Access Compliance Report

Public Rights-of-Way

(Curb Ramps)

Intersection ID: N/A	Main Street: SCHOLASTIC_DR	Cross Street: CLEMS_BRANCH_DR	Location: SW
ADA ID: C5D47B1AAED7	Ramp Type: Perp	Initial Pass/Fail: Fail	Overall Compliance: No
Severity Score: 25			
Codes/Mitigation Info/Possible Solution		Field Measurements/Component Compliance

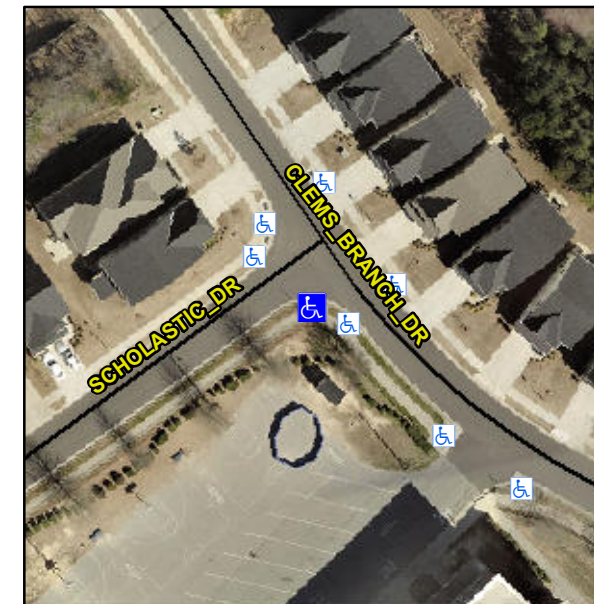
R304.2.2, R304.5.3

Compliance	Description	Data	Compliance	Description	Data
N/A	Ramp Length (in)	63.0	No	Ramp Slope (%)	10.6
Yes	Ramp Width (in)	48.0	No	Ramp XSlope (%)	6.7
N/A	Flare Type LT	N/A	N/A	Flare Type RT	N/A
N/A	Flare Slope LT (%)	N/A	N/A	Flare Slope RT (%)	N/A
N/A	Flare Traversable LT?	N/A	N/A	Flare Traversable RT?	N/A
N/A	Landing Length (in)	N/A	N/A	DWS Provided?	N/A
N/A	Landing Width (in)	N/A	N/A	DWS Contrast?	N/A
N/A	Landing Slope (%)	N/A	N/A	DWS Length (in)	N/A
N/A	Landing X Slope (%)	N/A	N/A	DWS Full Width?	N/A
N/A	Landing Curb? (Y/N)	N/A	N/A	DWS Offset (in)	N/A
N/A	Shared Landing?	N/A			
N/A	Gutter Ponding?	N/A	N/A	Gutter Slope (%)	N/A
N/A	Gutter Lip Ht (in)	N/A	N/A	Gutter X Slope (%)	N/A
N/A	Painted X Walk1?	No	N/A	Painted X Walk2?	N/A
	X Walk 1 Direction	To NW		X Walk 2 Direction	N/A
N/A	X Walk 1 Width (in)	N/A	N/A	X Walk 2 Width (in)	N/A
	X Walk 1 Slope (%)	4.6		X Walk 2 Slope (%)	N/A
	X Walk 1 X Slope (%)	0.5		X Walk 2 X Slope (%)	N/A

Remove & Replace Entire Ramp.
